Comments of Head of Geotechnical Engineering Office, CEDD dated 9.7.2024

Executive Summary

1. The application site is on Lots 788 (Part), 790 (Part), 793, 794 and 801R.P. in D.D. 381 and Adjoining Government Land (not yet occupied), Tuen Mun, New Territories.

2. The applied use is “Proposed Temporary Place of Recreation, Sports or Culture (Barbecue Area) and Temporary Holiday Camp (Private Tent Camping Ground)” for a Period of 6 Years.

| 1:1000 | Plan showing the distance between the foot of the man-made slope and the nearest structure | Goldrich Planners & Surveyors Ltd. |

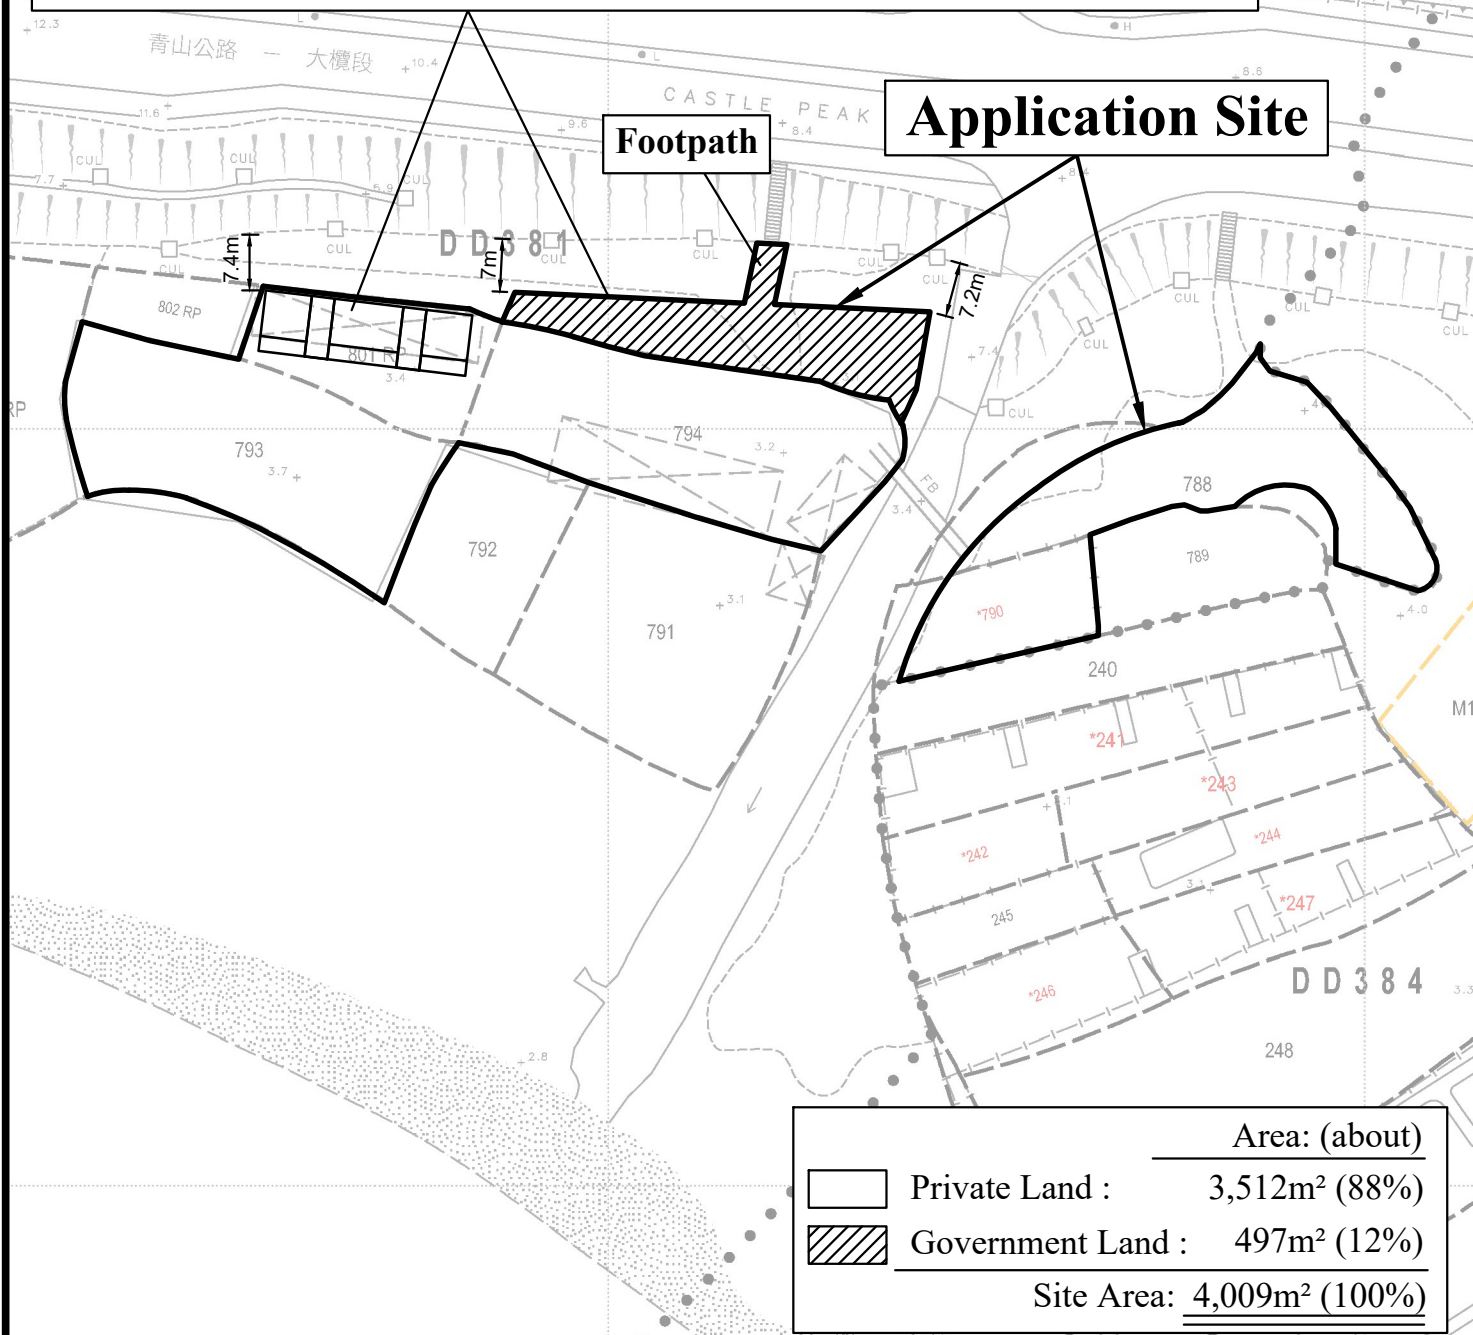
| | Comments | Responses |
|----|---|--|
| 2. | R-to-C item 2 and Plan 4a in the FI - The applicant's responses are noted. It is noted that some tents are proposed on the adjacent Government Land at the toe of Feature no. 6SW-D/F278 (maximum height about 10m). As such, the subject application meets the criteria for submission of a Geotechnical Planning Review Report. | The layout is updated. The tent camping ground area is away from the slope at a distance of at least 7m. Please refer to the revised plans (Plans 3b and 4b). A GPRR may not be required. |

The proposed Government Land is about 7m from the foot of the man-made slope.

The nearest distance of the structure is about 7.4m from the foot of the man-made slope.

No construction works will be carried out.

The proposed activity will not affect the stability of the man-made slope and the retaining wall.

Therefore no Geotechnical Planning Review Report is required.

**Plan 5a
 (P 22015)**

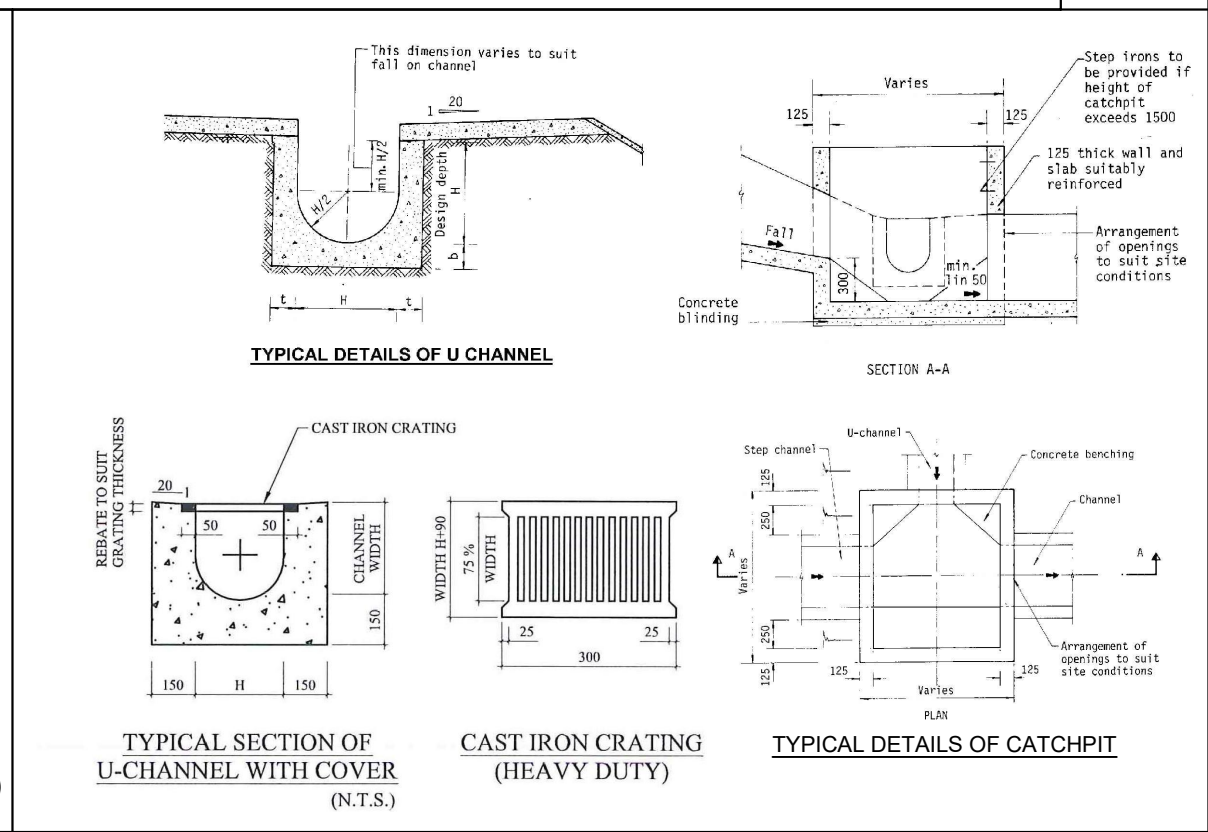
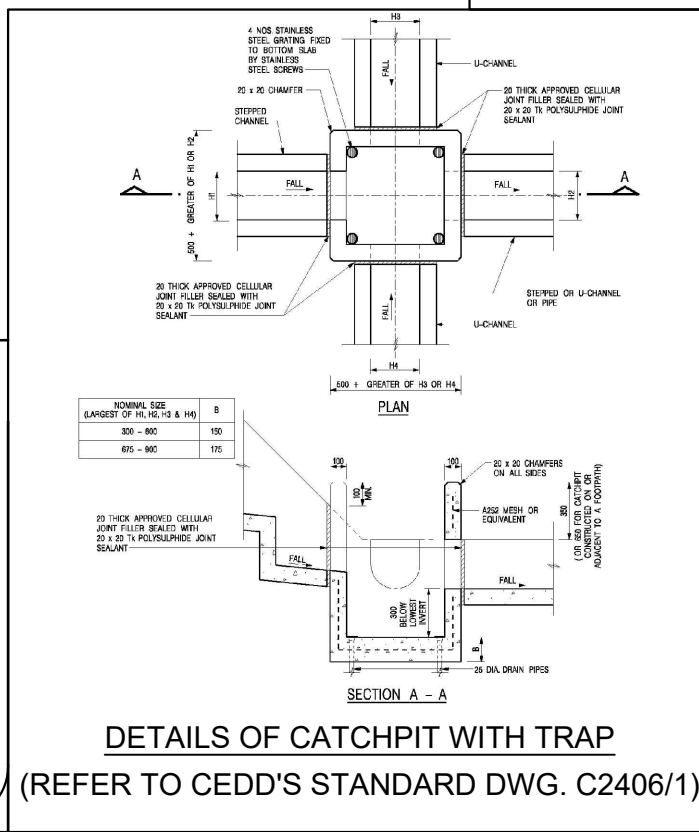
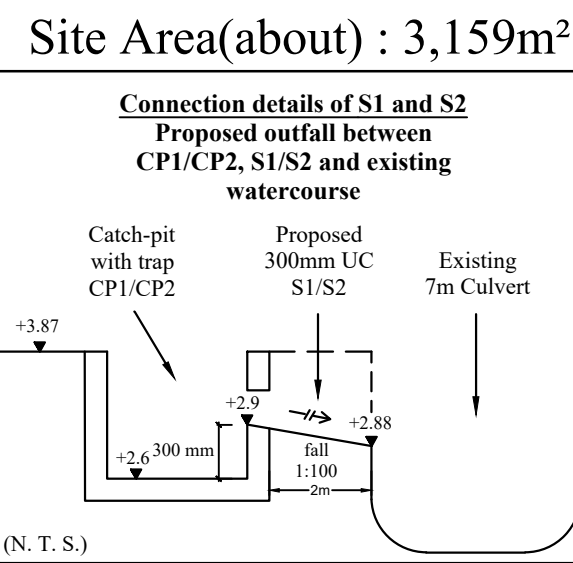
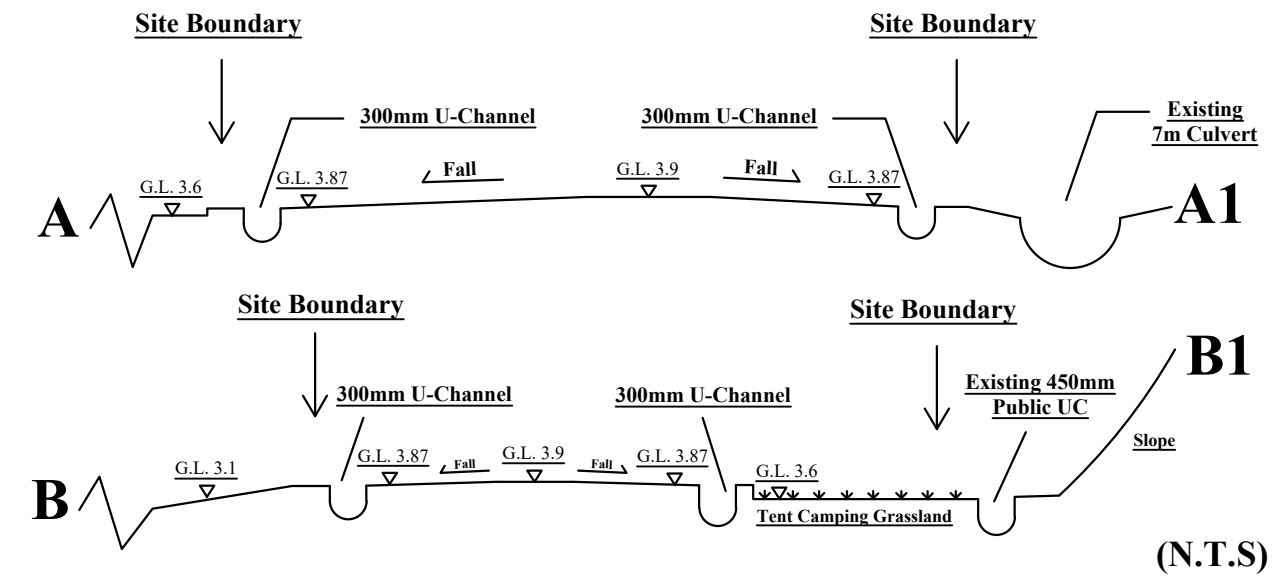
| | Comments | Responses |
|-----|---|--|
| 1. | The catchment plan and proposed drainage plan are missing. Please provide. | The catchment plan and proposed drainage plan are attached (Plan 5a). |

Plan 11
(P 22015)

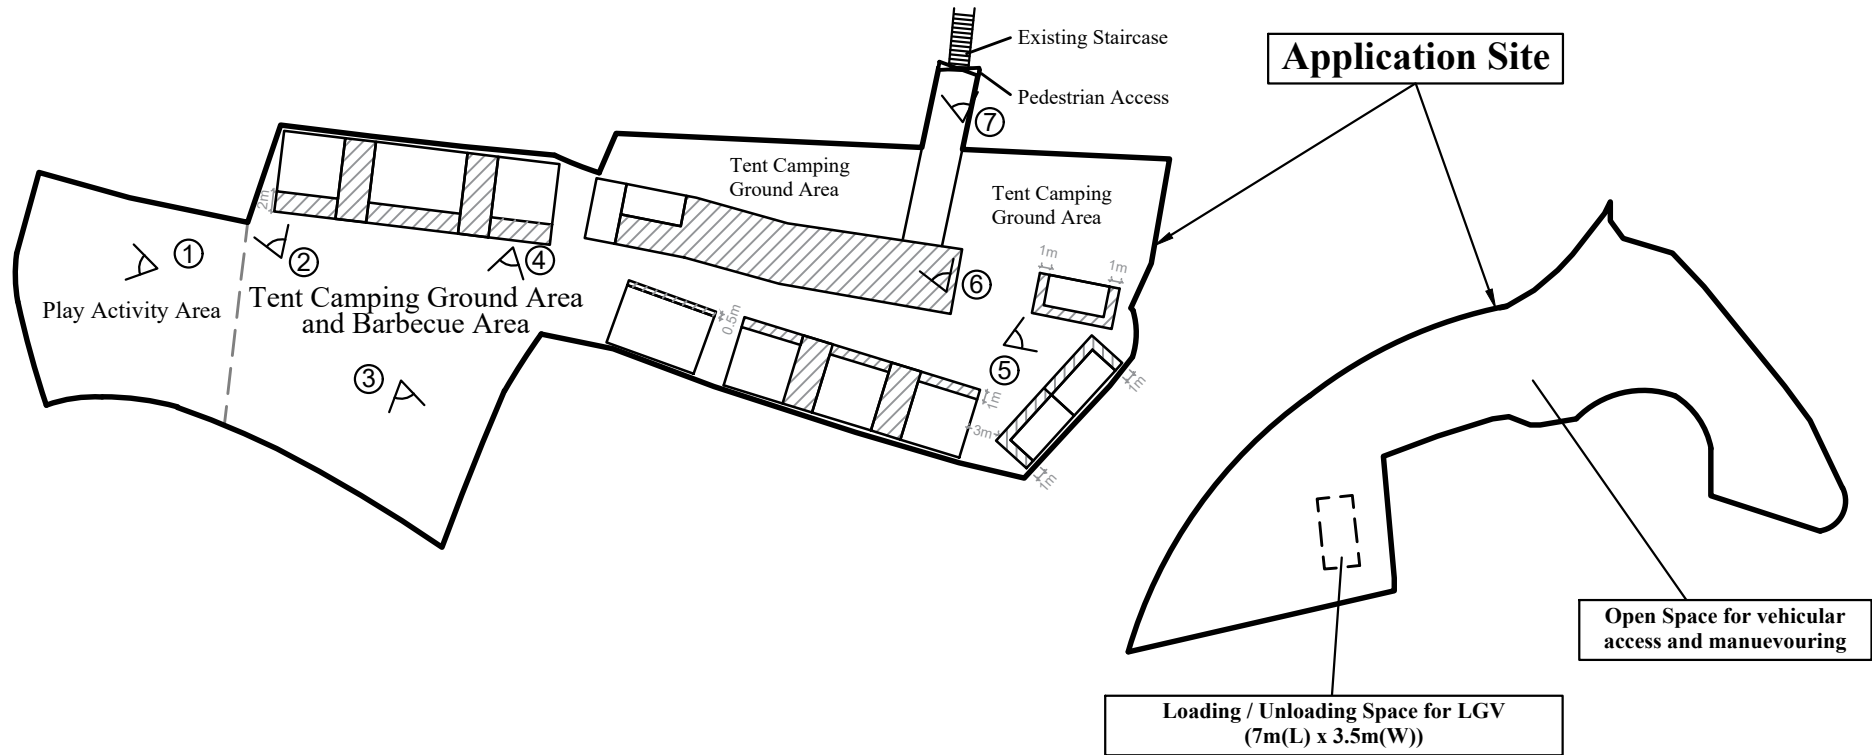
| | Comments | Responses |
|----|---|--|
| 2. | <p>A site inspection conducted on 27.6.2024 revealed that all unauthorized structures such as tents and porches identified during the site inspection in April 2024 remained intact and not covered by the subject planning application. Meanwhile, the height of Structure 1 for office purposes as marked on Plan 3a (P22015) did not reflect the actual site condition (i.e. a converted-container with advertisement board about 4.5m). Besides, some miscellaneous items were newly found on Government land without our permission, including a wooden gate and some advertising stands mounted on the railings, some stands with lights fixed to the ground along the staircase leading to the site, and a wheeled advertising board placed on Government land. The applicant should remove the said miscellaneous items on Government land.</p> | <p>The height of structures has been revised to 6m. Please refer to the revised layout plan (Plan 3b) for details. The tents and porches have been removed. The advertisement board has been removed. The miscellaneous items on Government Land have been removed. Please refer to the Plan Showing Viewpoints of Site Photographs (Plan 11) and the site photos (Viewpoints 1-7) for details.</p> |
